Addendum #02

Date: July 2, 2021

Project: Huntington Middle School Modernization and Addition

A203

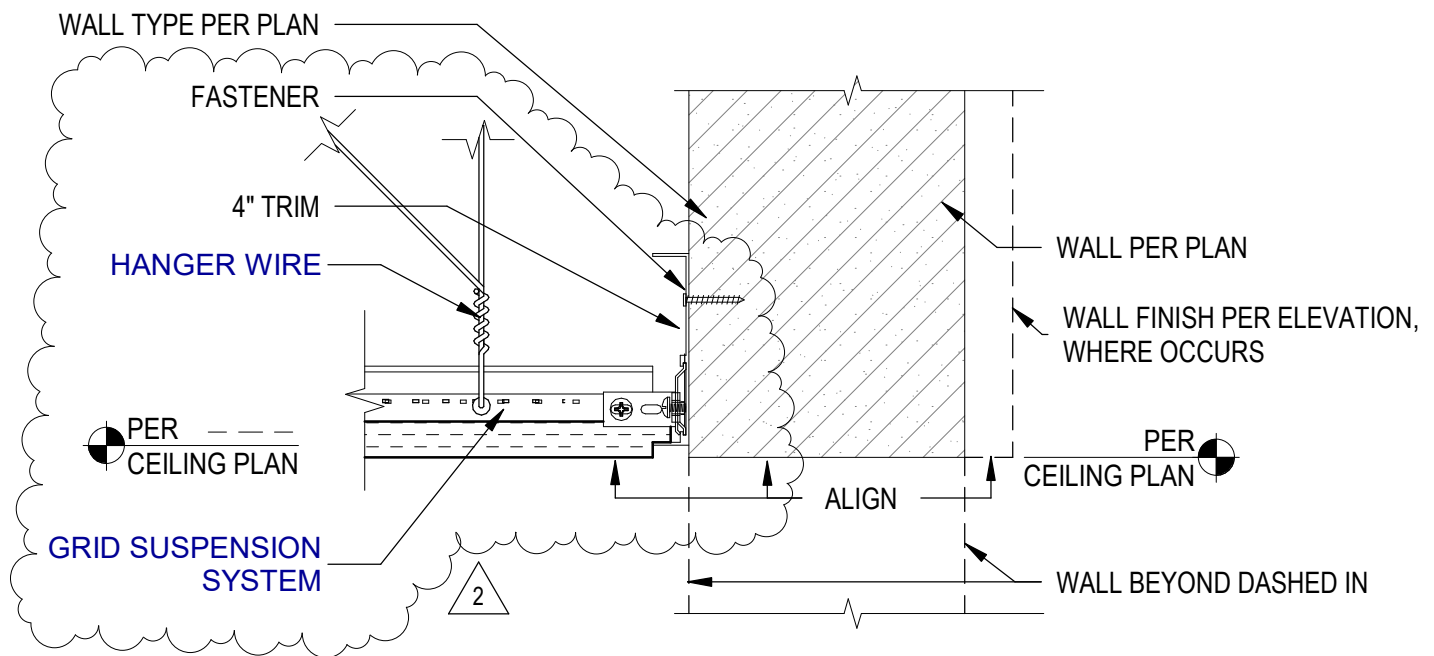
Item #A02 A203– EXTERIOR ELEVATIONS
Add. #02 **Revise:** 2/A203 per attached **ADA-013**

A481

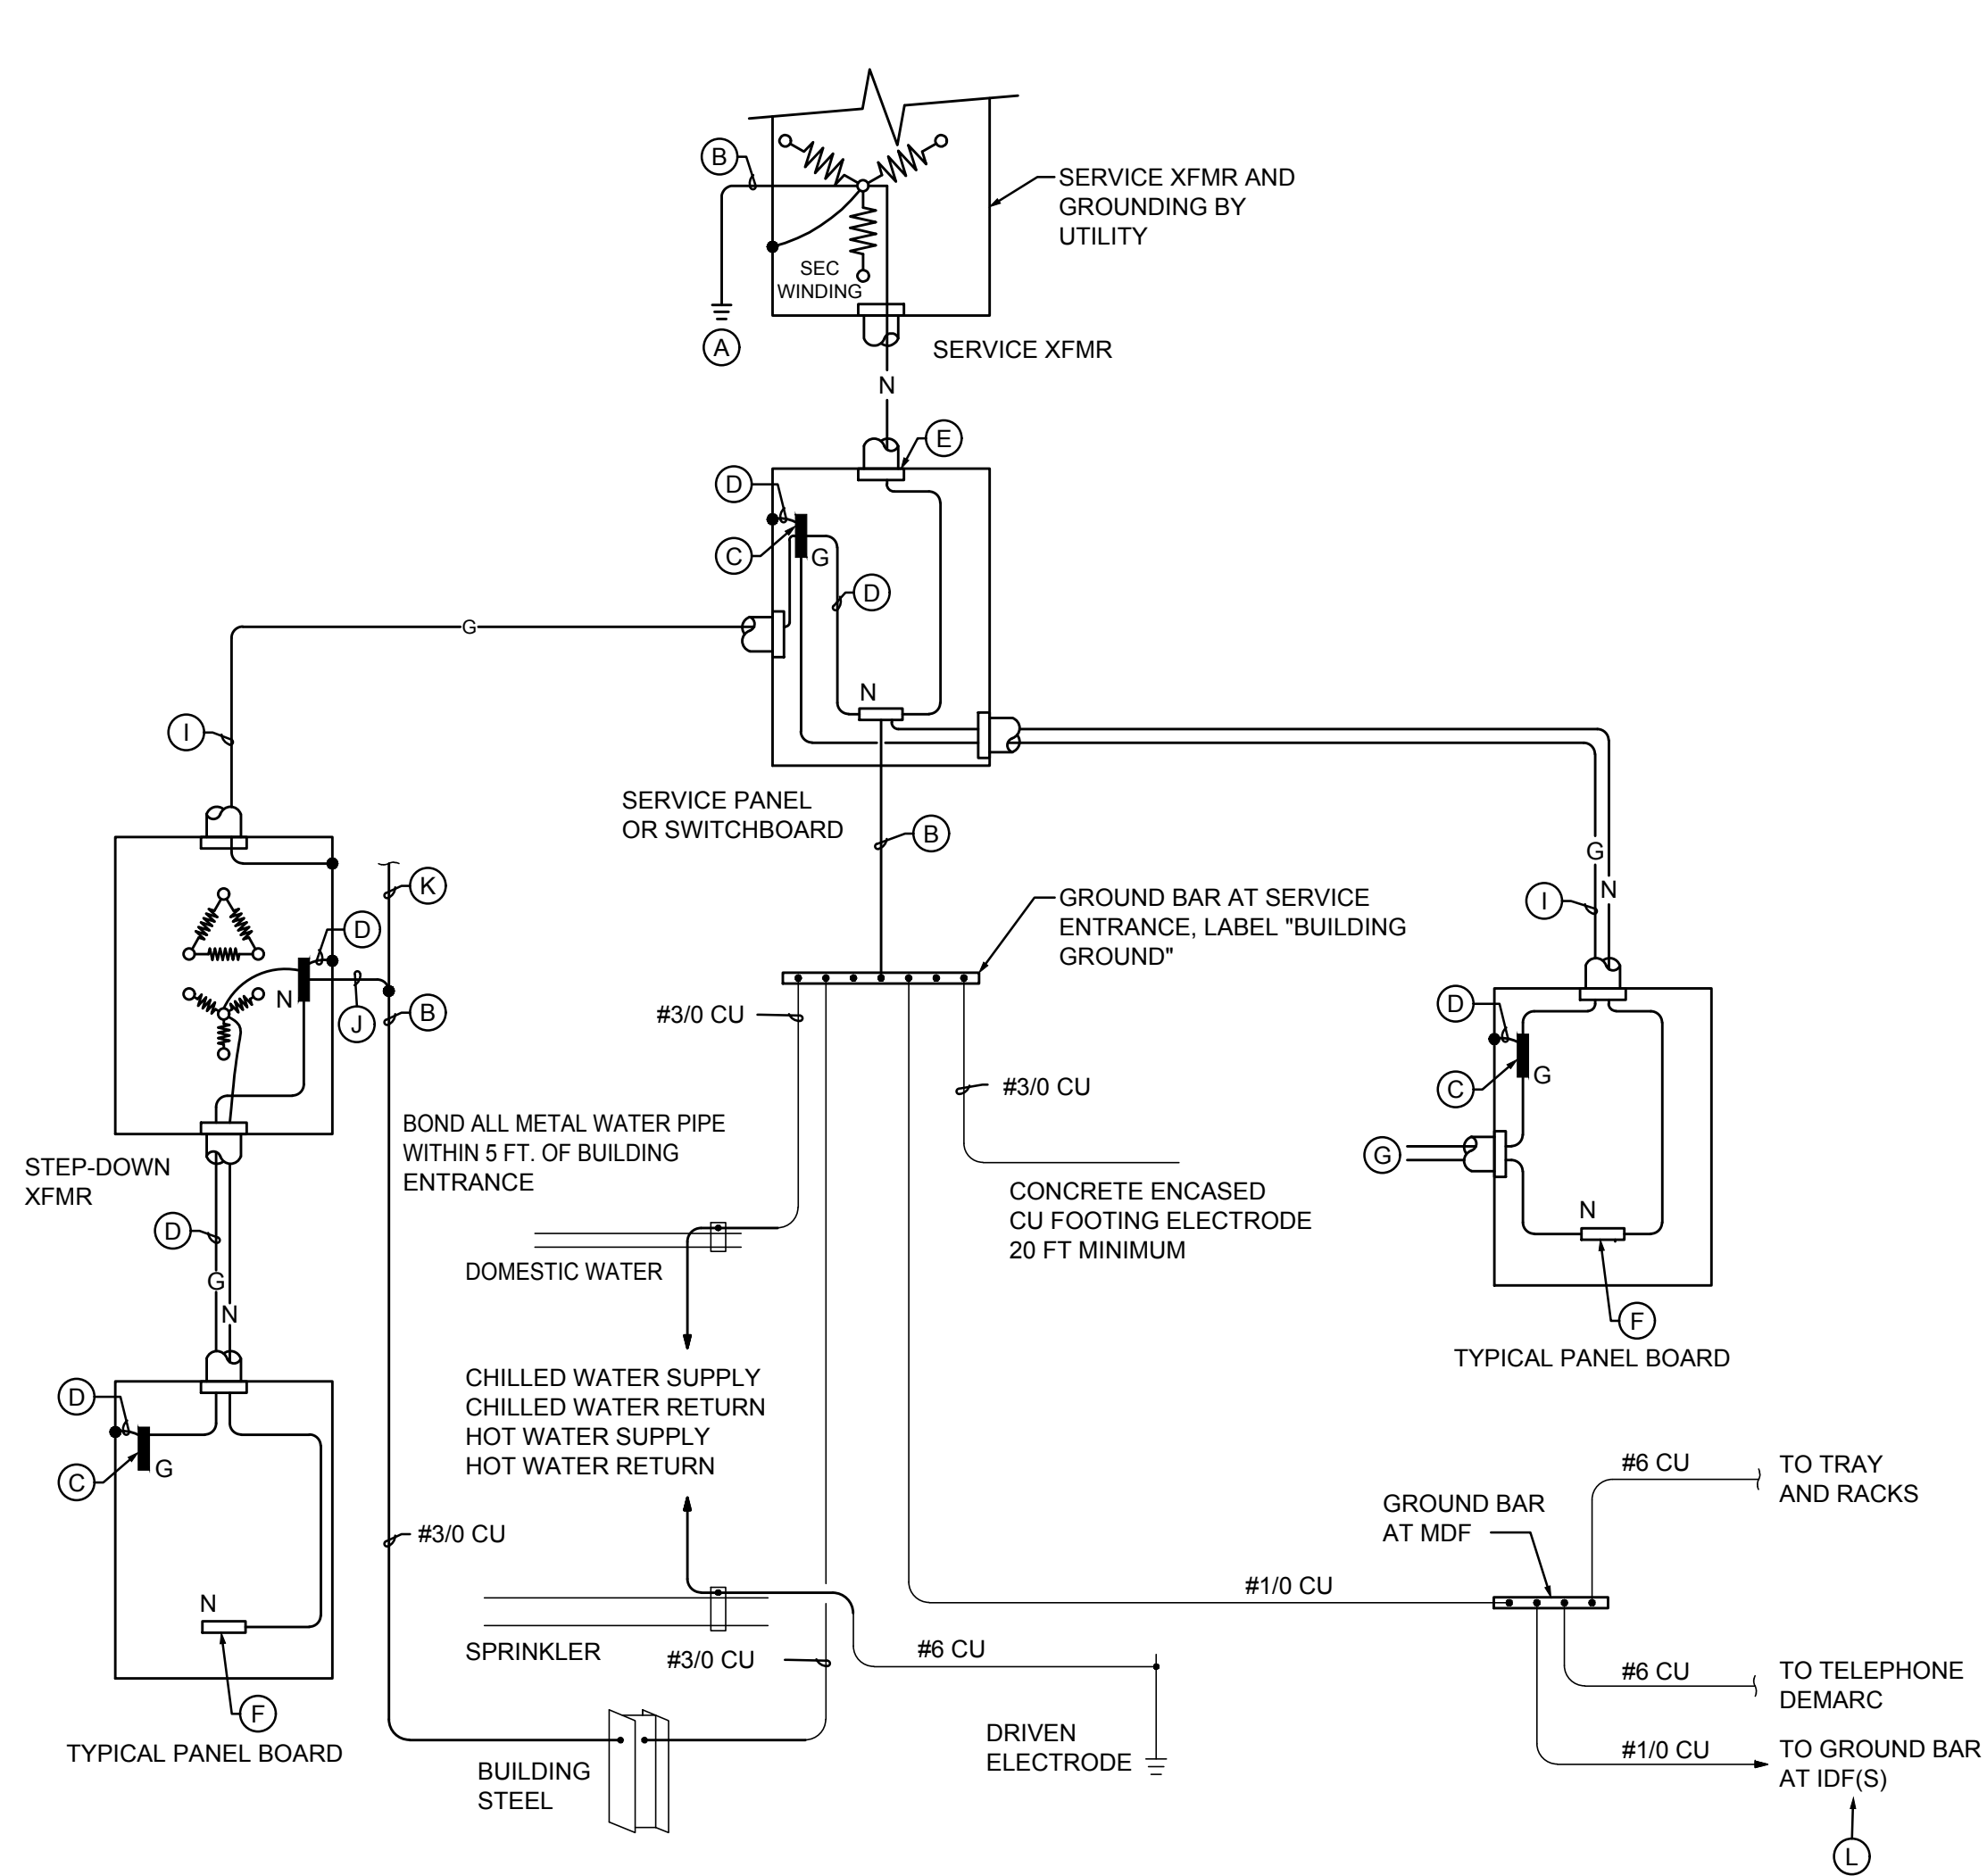
Item #A03 A481– CEILING DETAILS
Add. #02 **Revise:** 14/A481 per attached **ADA-014**

DISTRIBUTION DIAGRAM

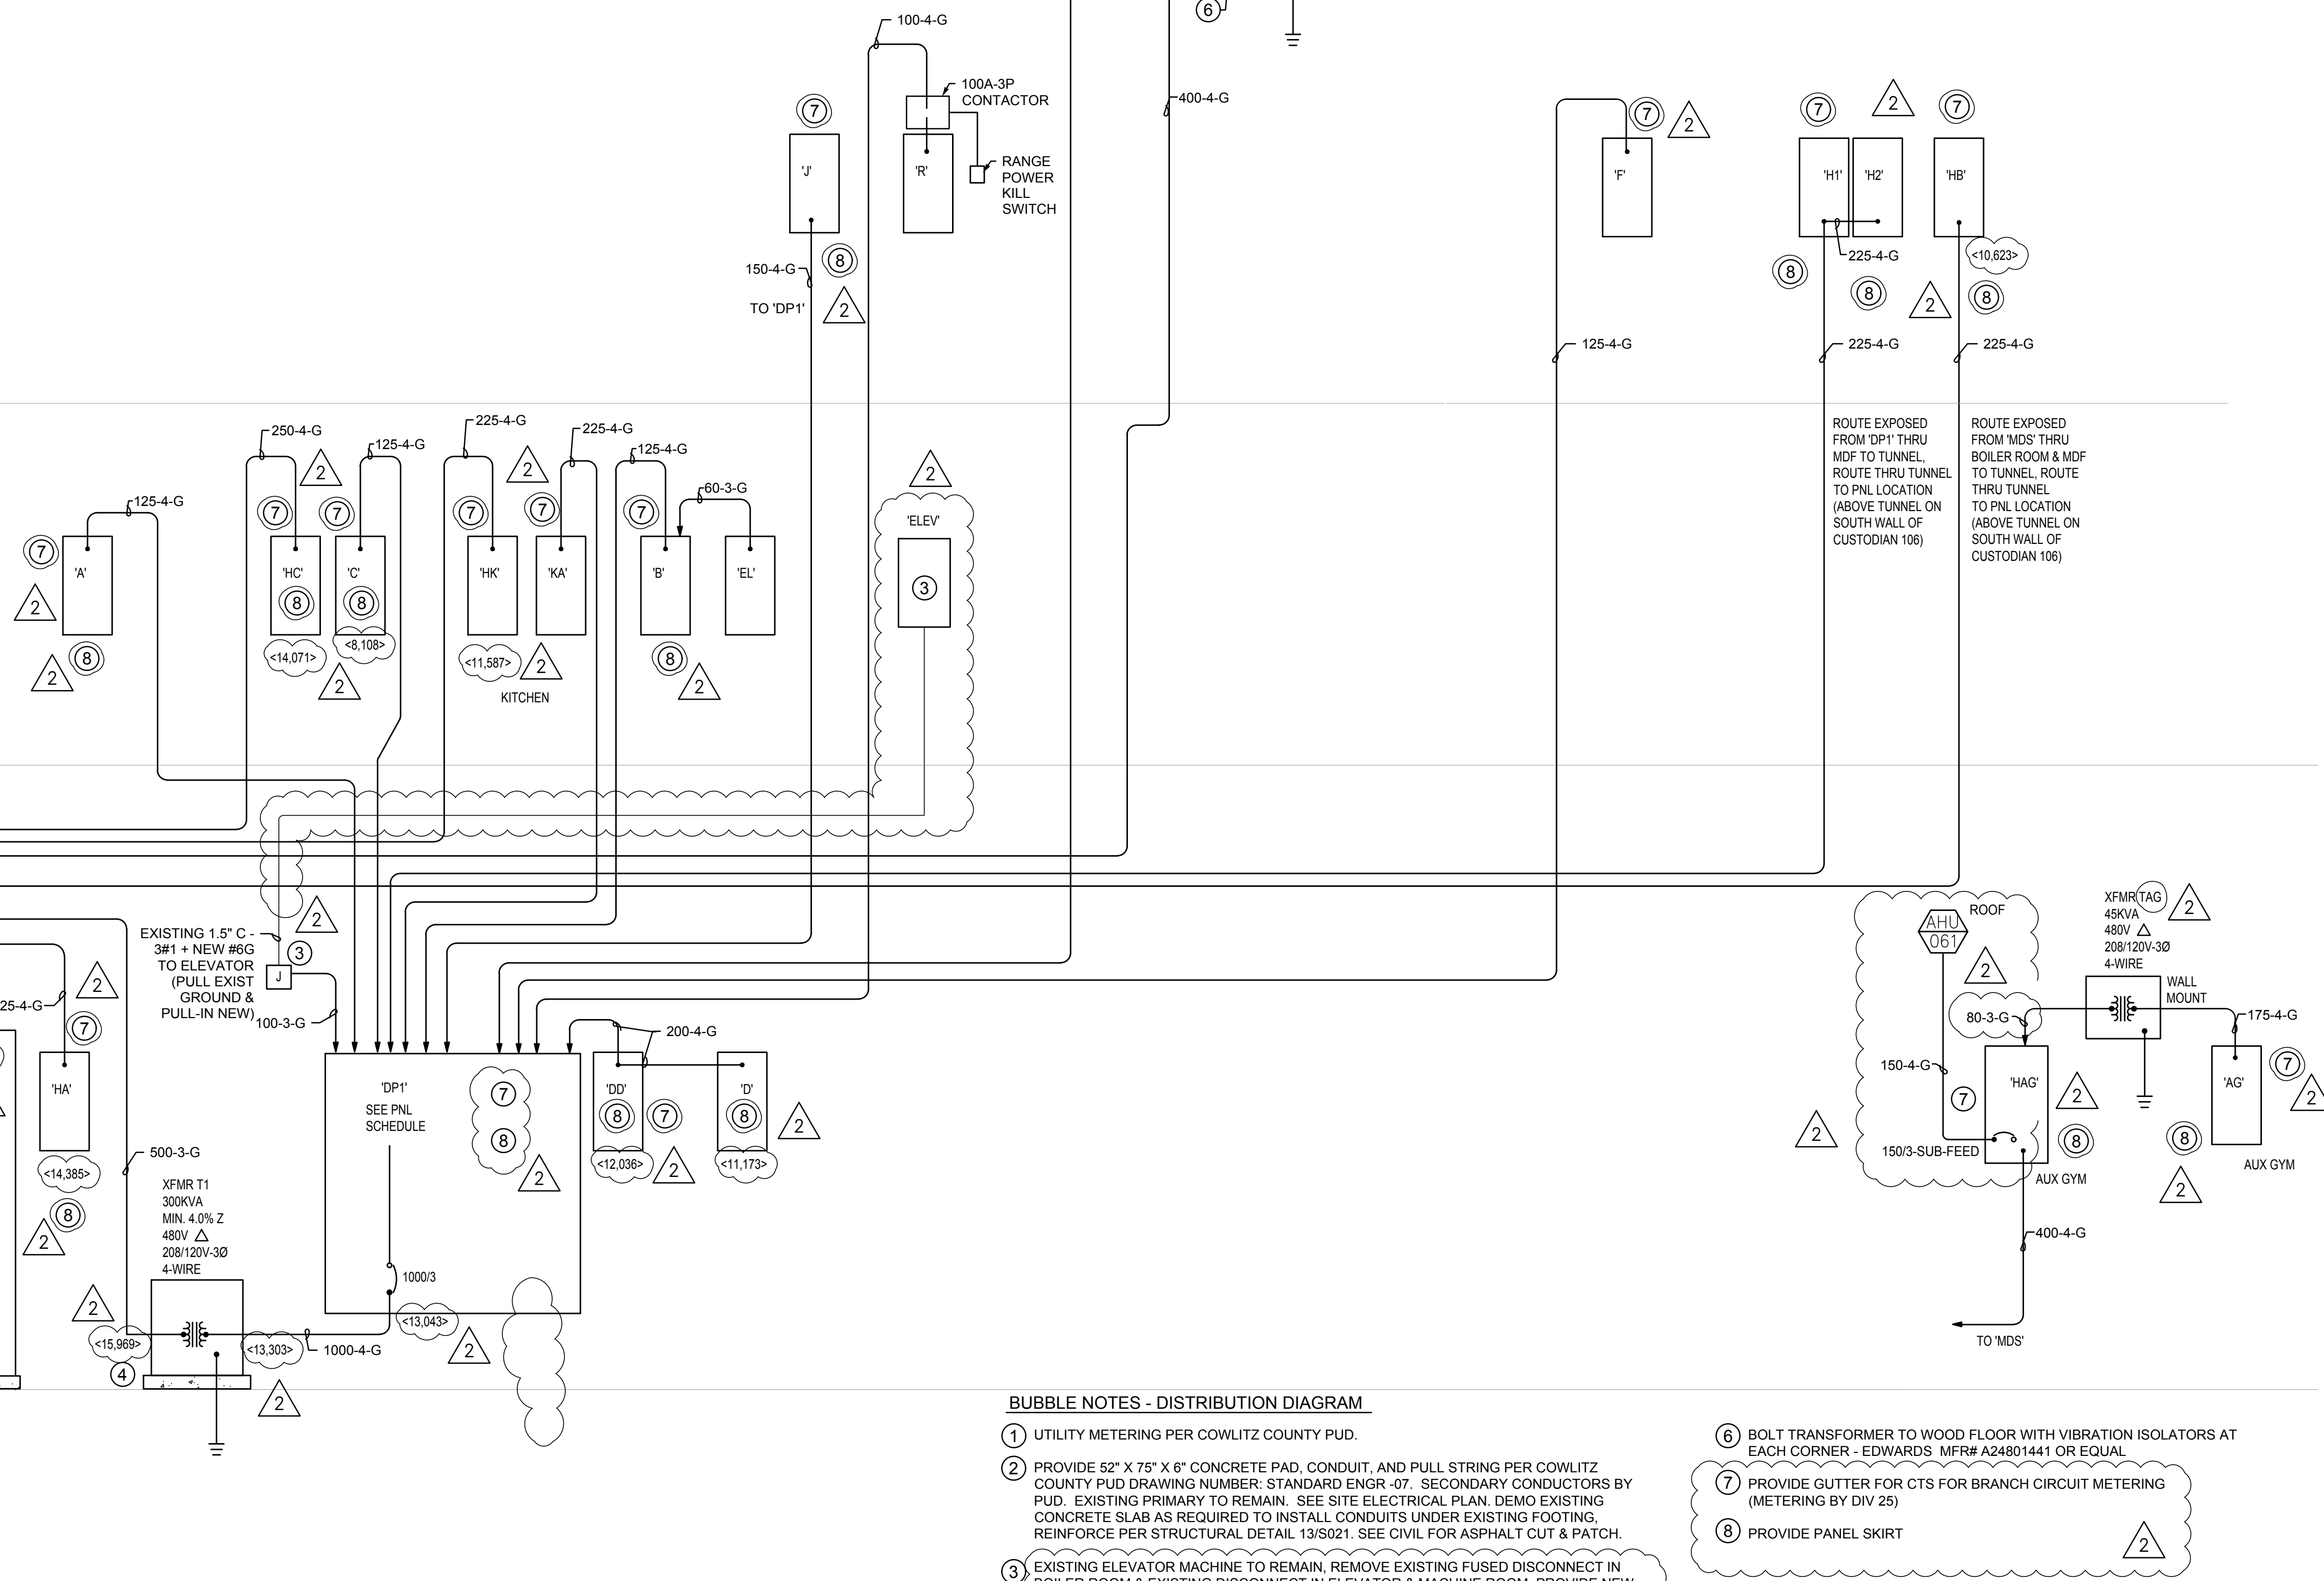
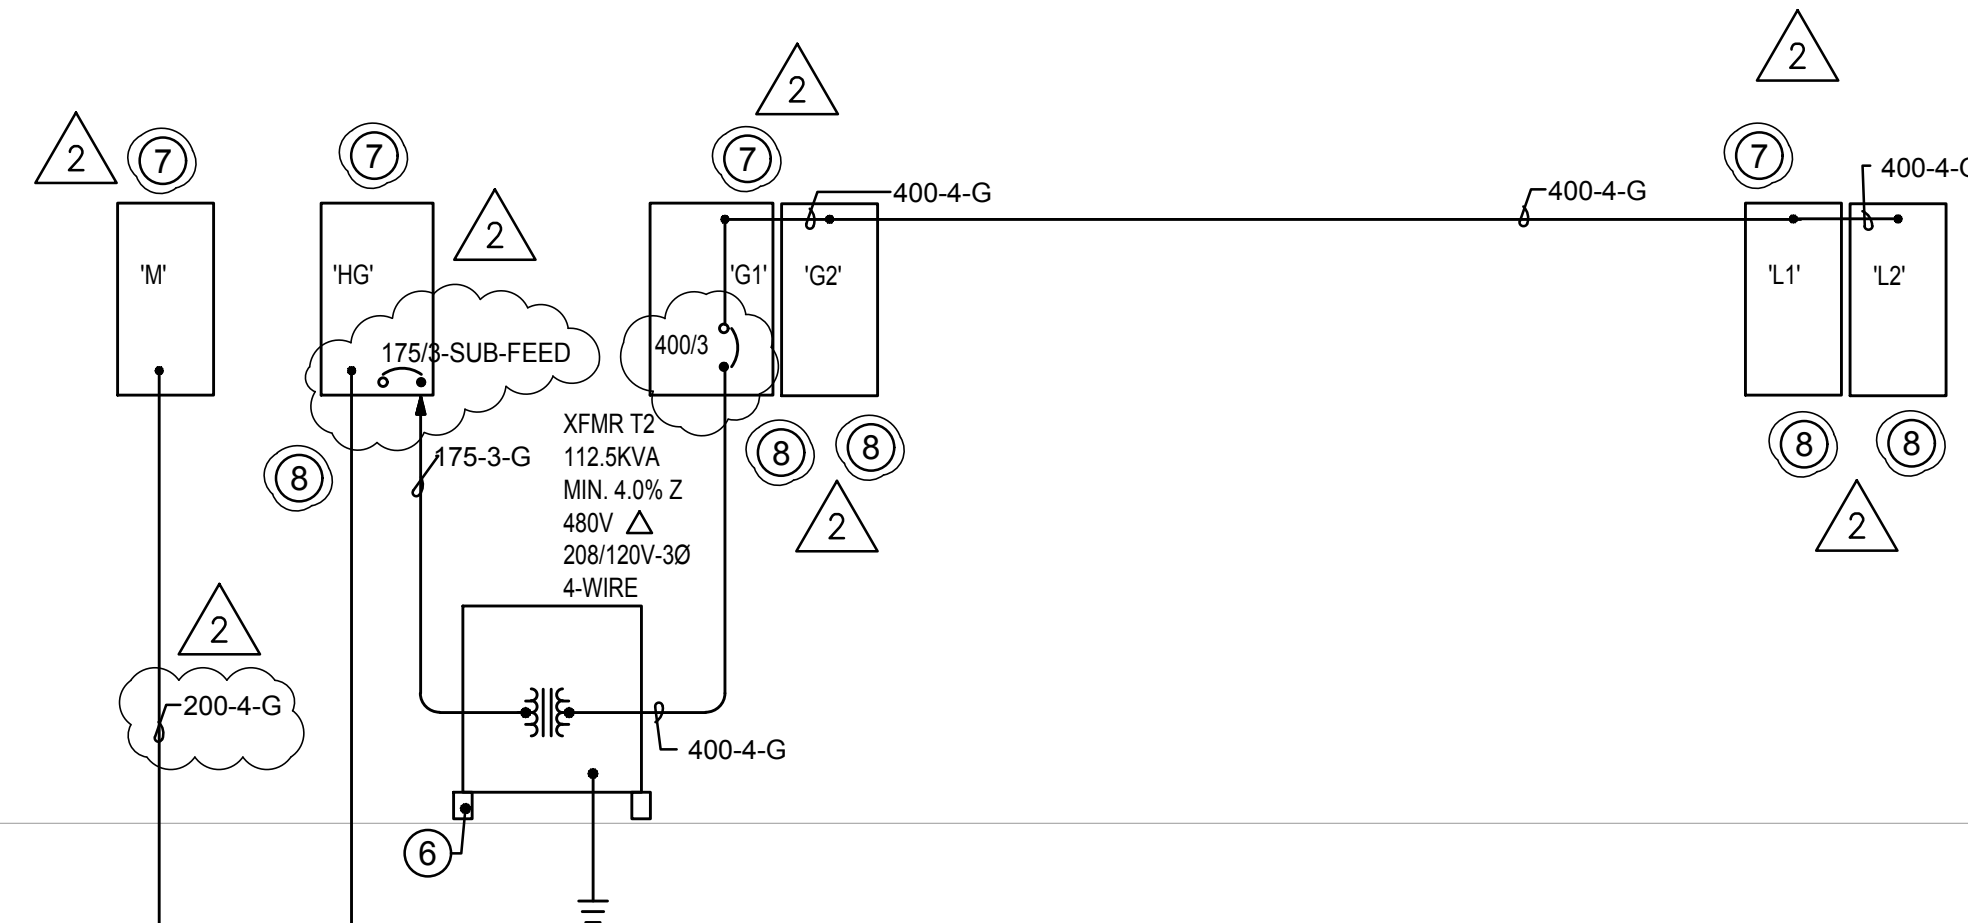
Add. #02 **Revise** per attached sheet **E500**.

Add. #02 Panel MDS: **Revise** AIC Assembly to “X 100K FUSED SWITCH”.

Panel HAG: **Revise** 75A/3P on circuits 25,27,29 to 70A/3P.

Panel HA: **Revise** AIC Assembly to “X 35K”.

Panel HC: **Revise** AIC Assembly to “X 35K”.

Panel HG: **Revise** 175/3P on circuits 37,39,41 to a sub-feed 175/3P circuit breaker.

Panel HK: **Revise** AIC Assembly to “X 35K”.
